**Re: Modification Request – Concept Plan Approval for Redevelopment of the Former Allied Mills Site, 2-32 Smith Street, Summer Hill (MP10\_0155 MOD1)**

## Attachment 1: Architectural Drawing Package

SUMMER HILL FLOUR MILL\_  
VIEW ANALYSIS  
SHEET 01

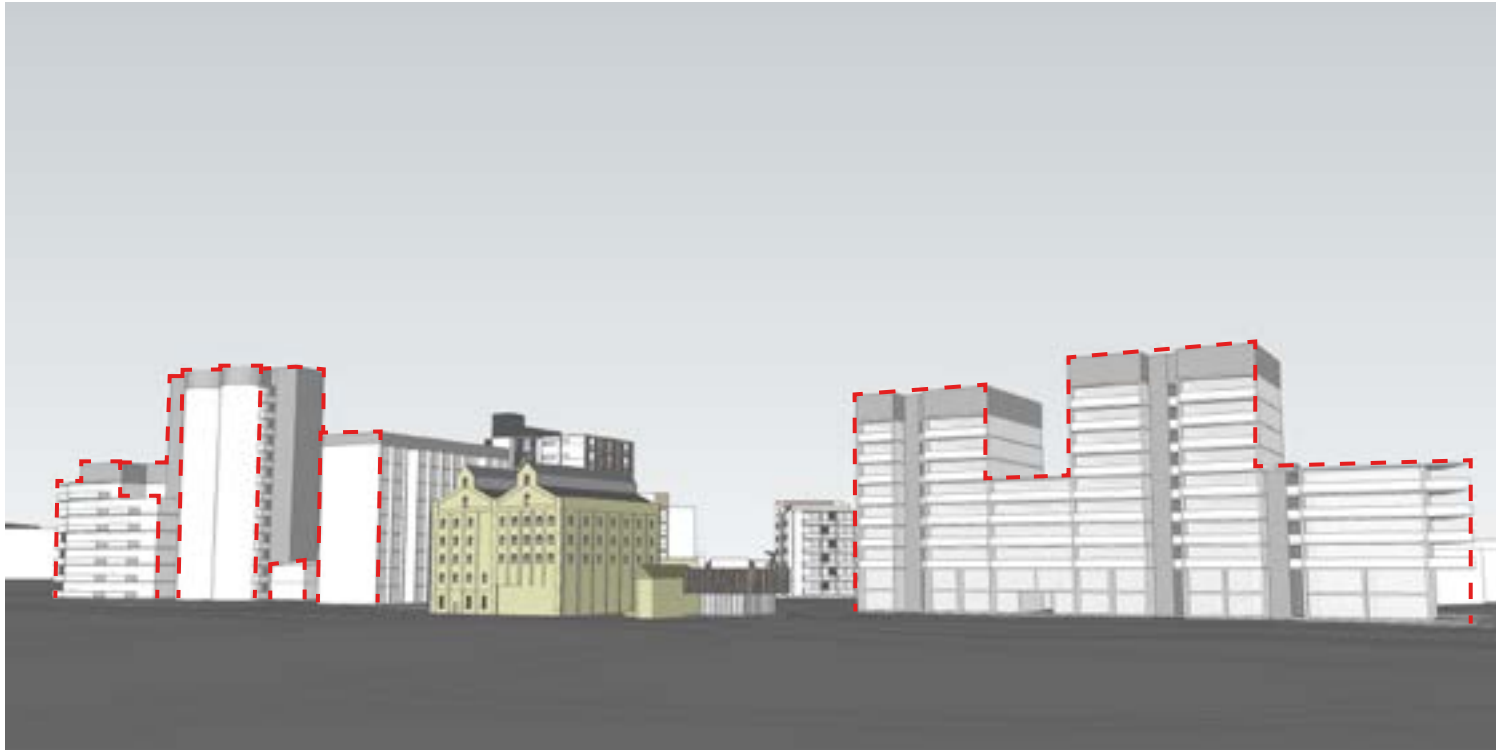
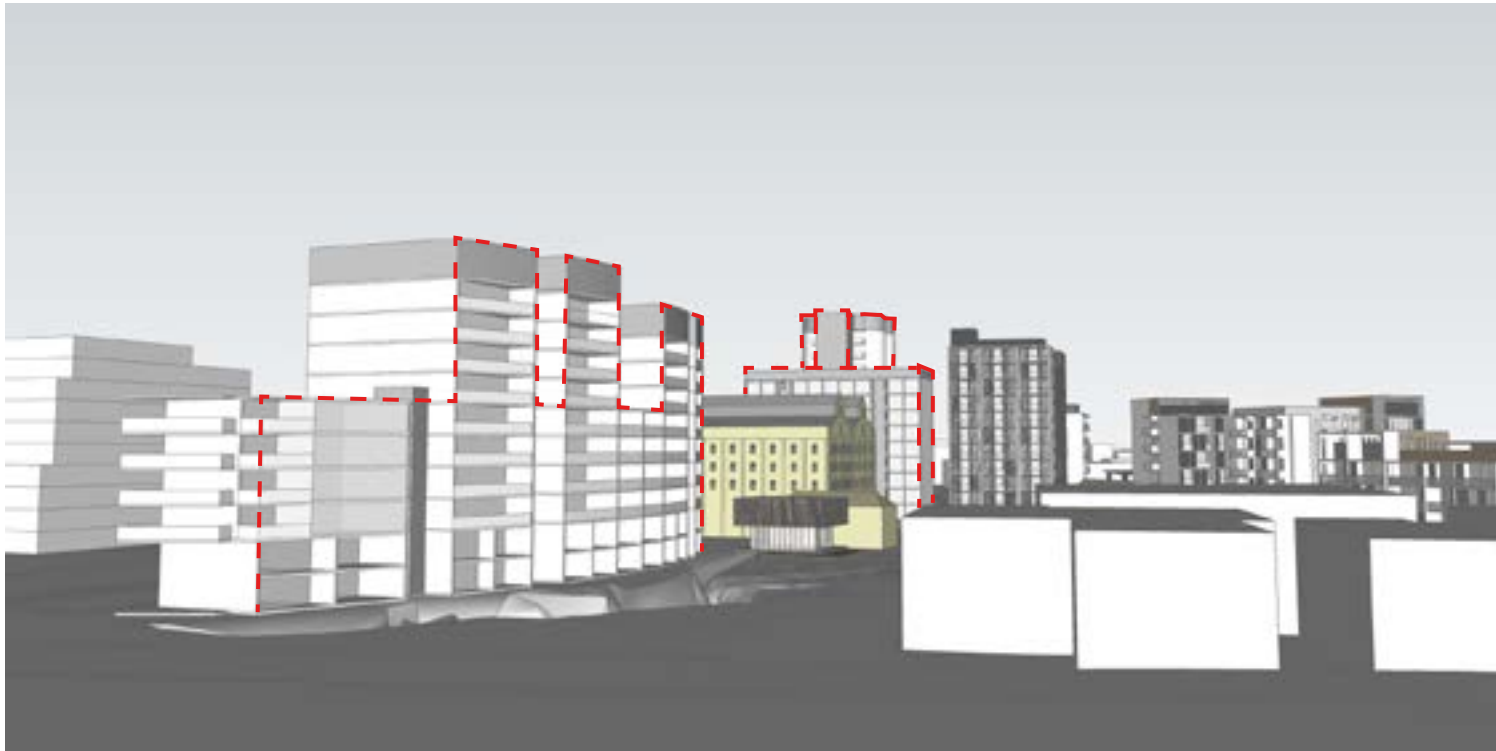
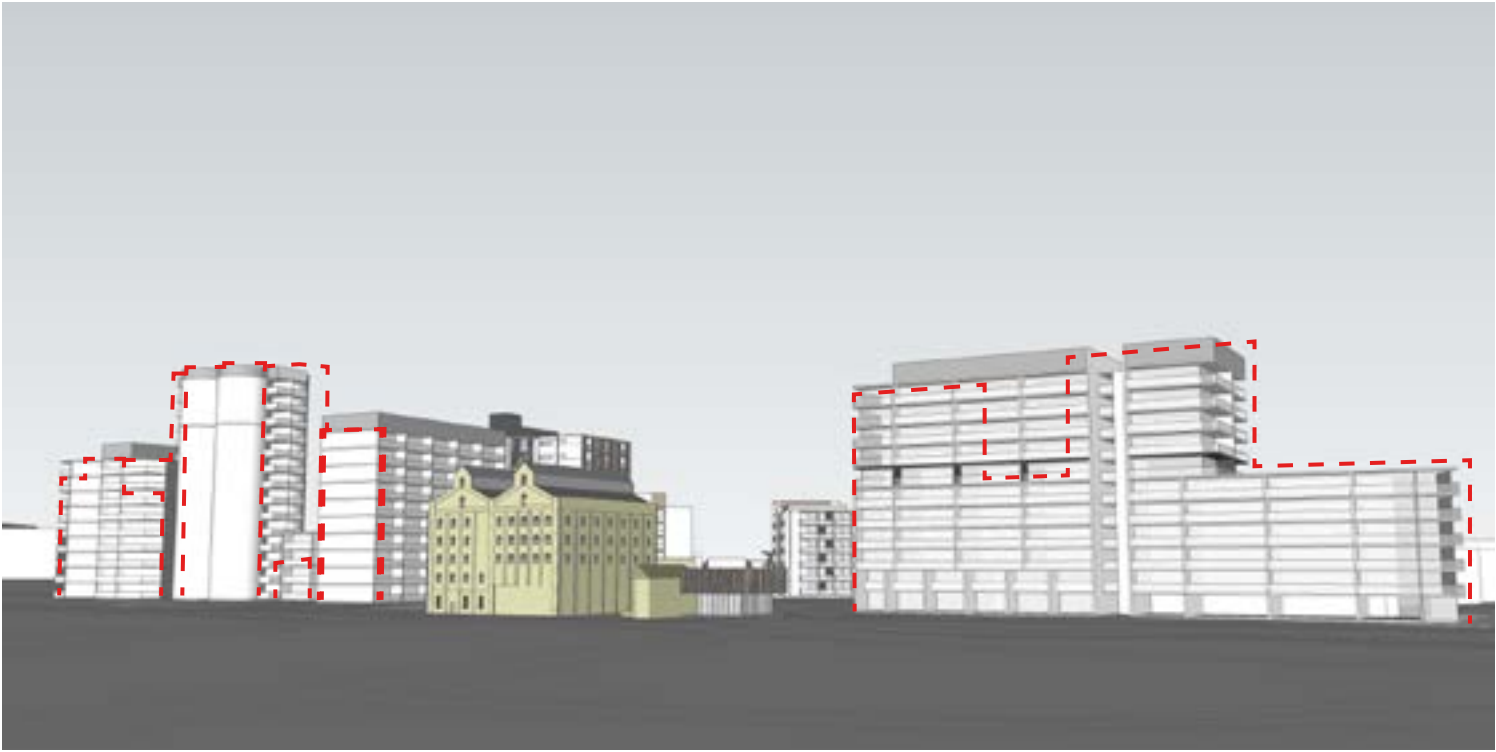
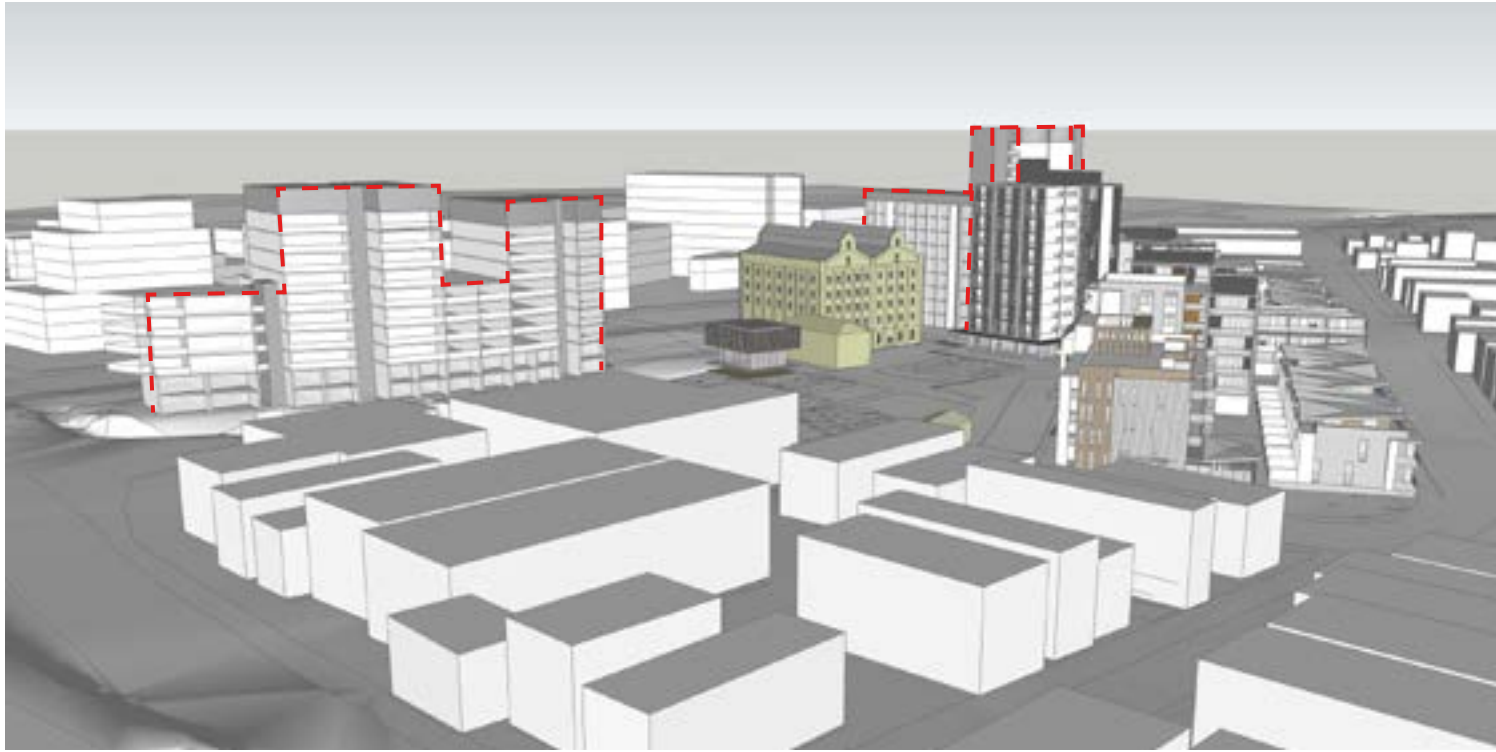
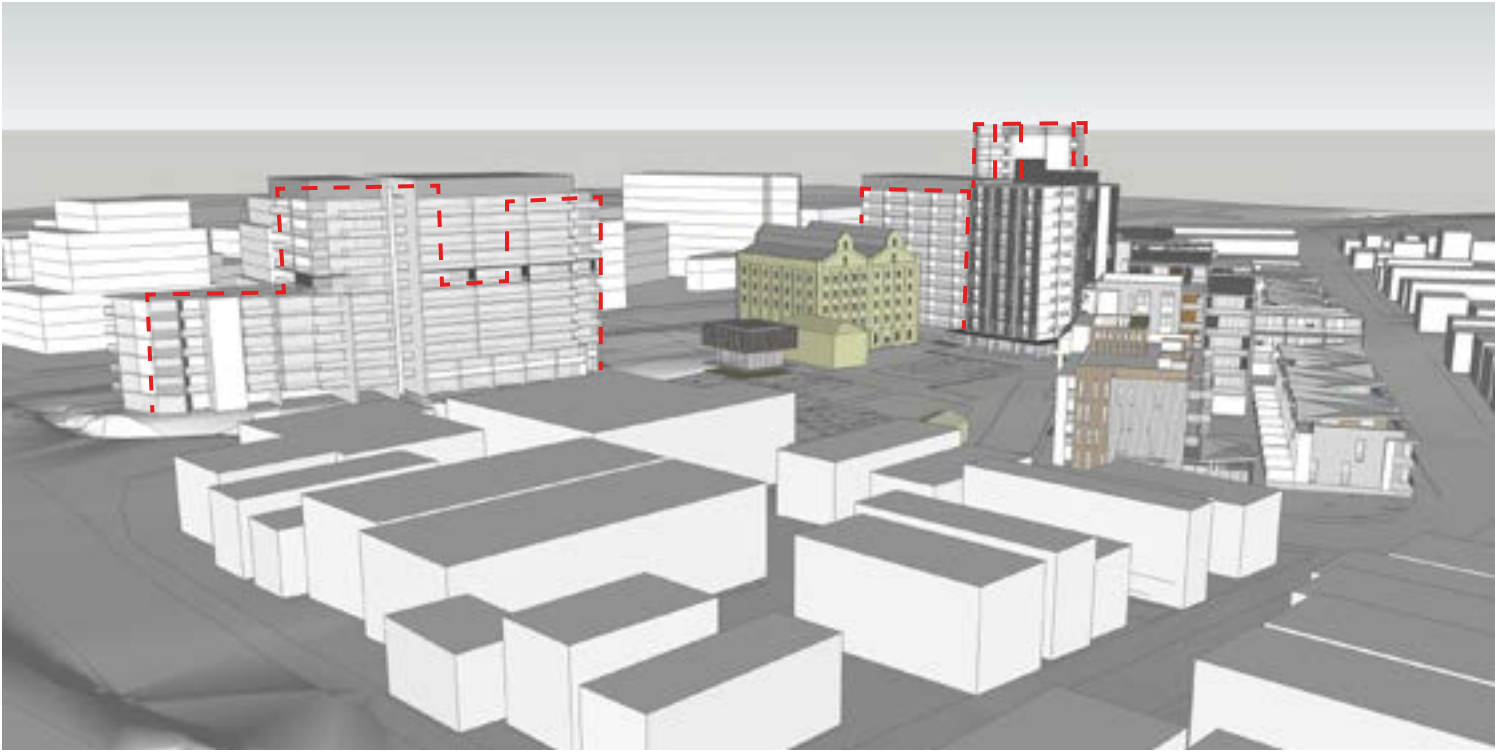
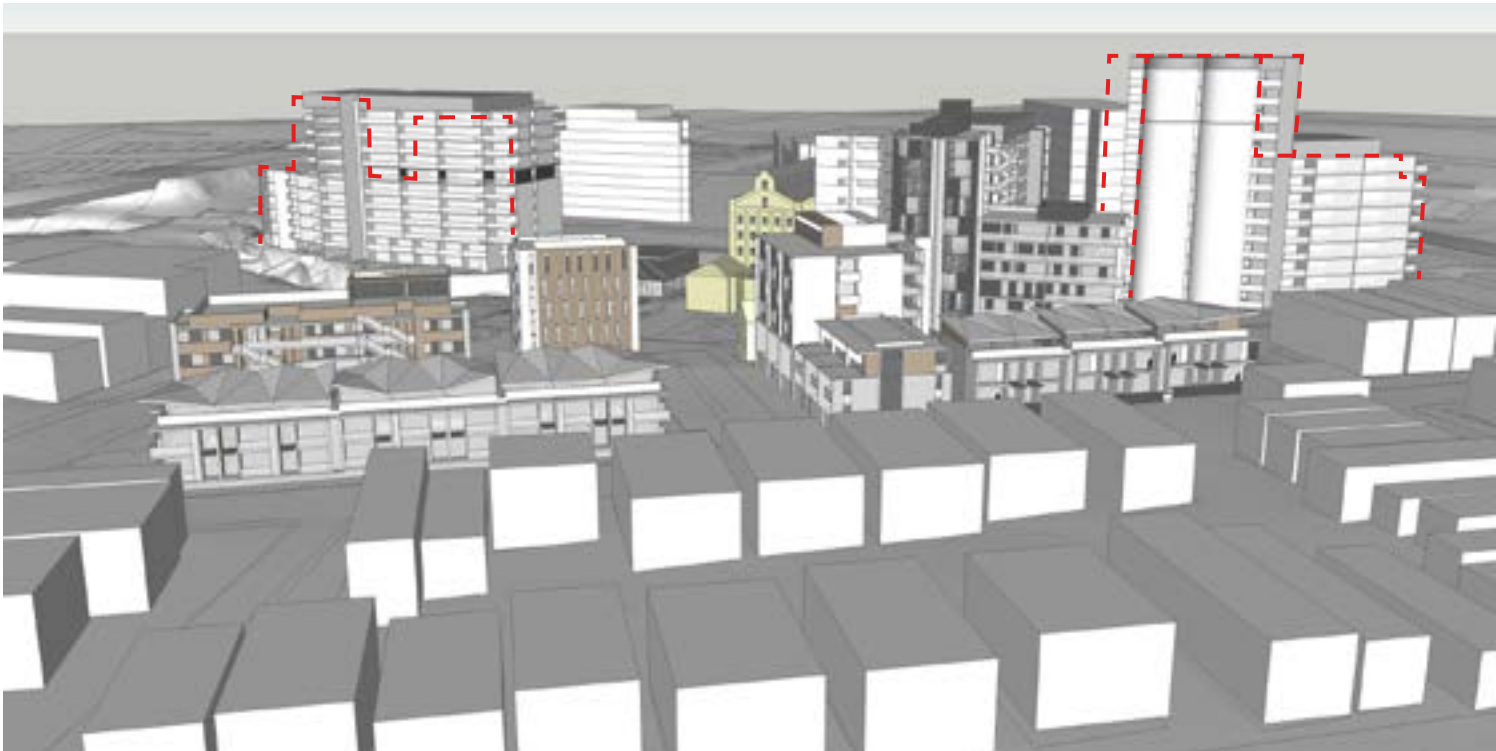
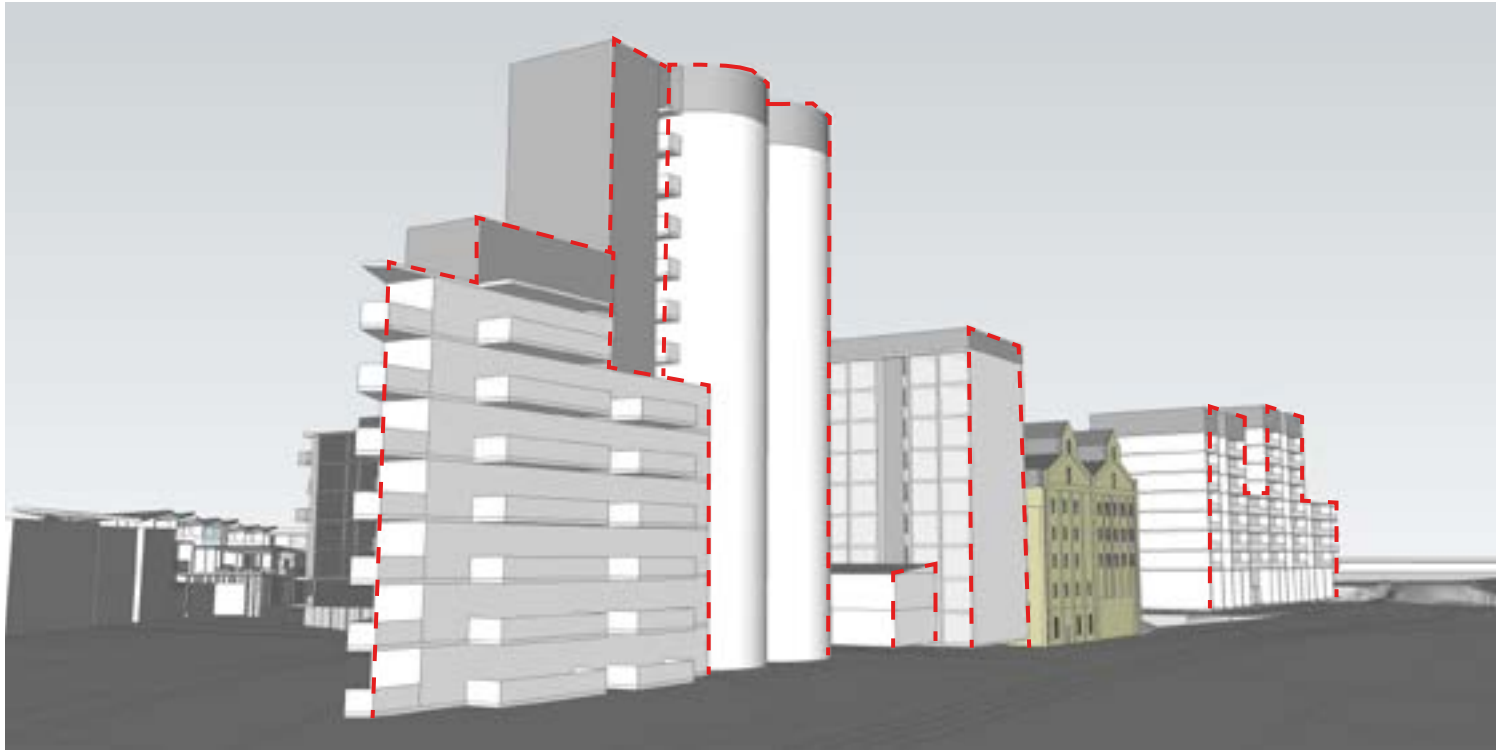
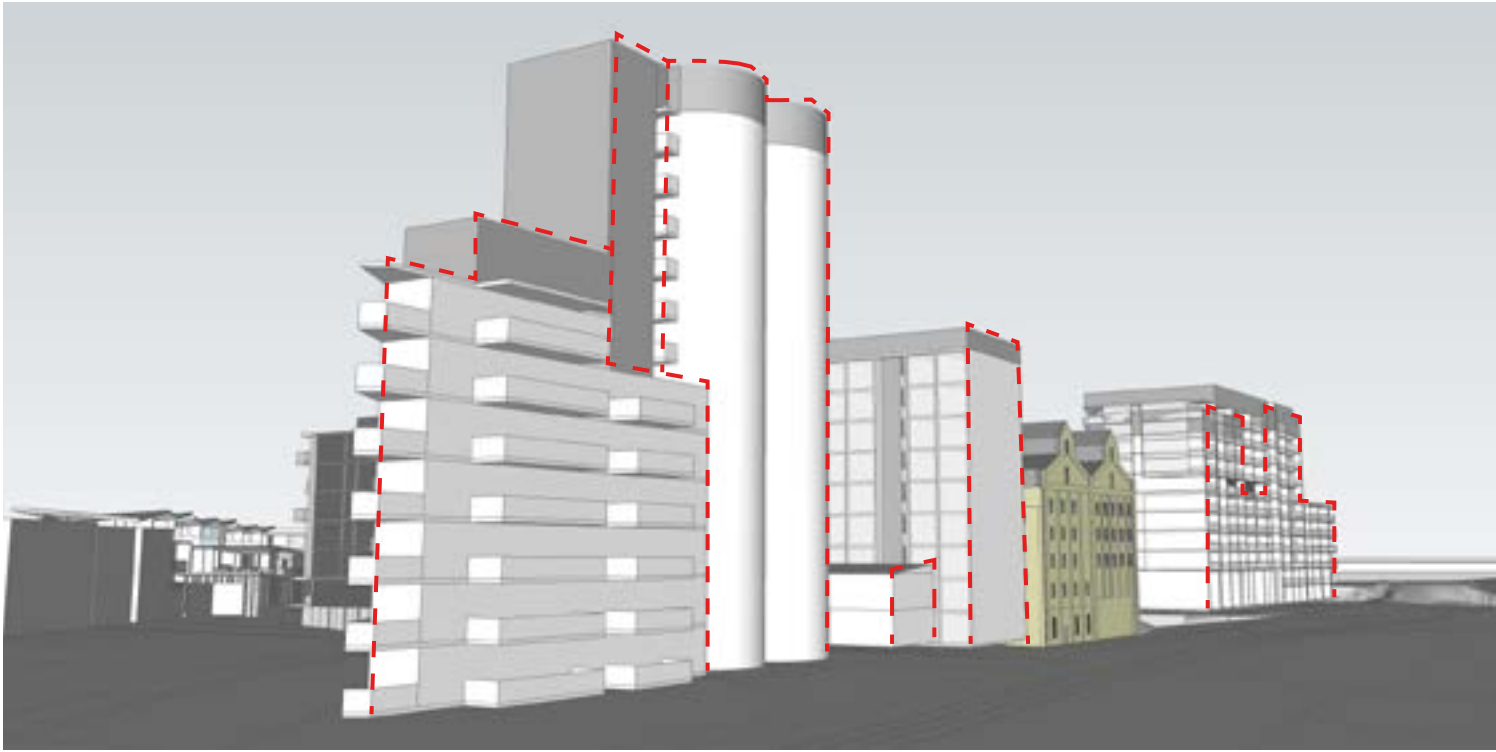
As shown in the design guidelines and visualisations, the proposed height to 47.4m is sought to accommodate a recessed roof plant zone. The parapet level of the building able to be accommodated within the requested envelope would therefore sit between the two (2) current approved top RLs of 44.2m and 47.4m.

The visualisations demonstrate that the relationship between the proposed envelope and the approved envelopes opposite the site are not inconsistent.
